1984 - 1987 Corvette: Service Bulletin: Loose Corvette Door Trim Panel

Bulletin Number: 87-116, Number 10

Date: April, 1987

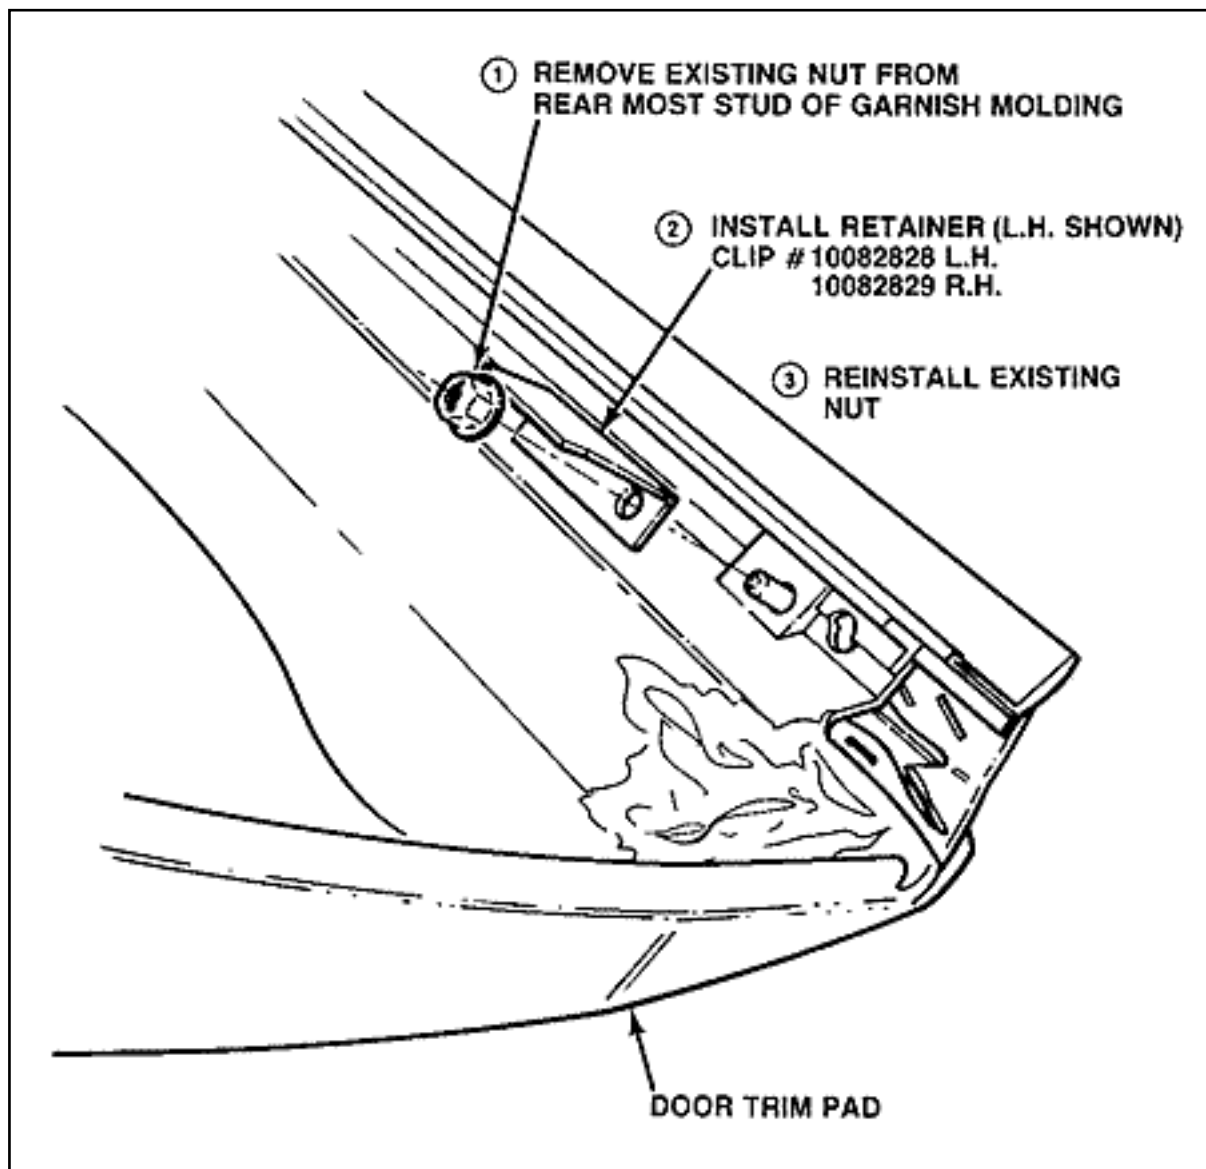
Some 1984-87 Corvette door trim pads may be loose from the door inner panel at the rear upper edge of the door.

If this condition is found it may be repaired by adding a retainer to the door trim panel using the following procedure.

1. Remove door trim panel per instructions in the Corvette Shop Manual.
2. Install retainer, P/N 10082828-9, L.H./R.H. as illustrated, to the trim pads rear upper garnish molding stud using spin nut. (See Illustration)
3. To remove a trim panel with a retainer, push trim panel upward and outboard to disengage clip from door inner panel at beltline.
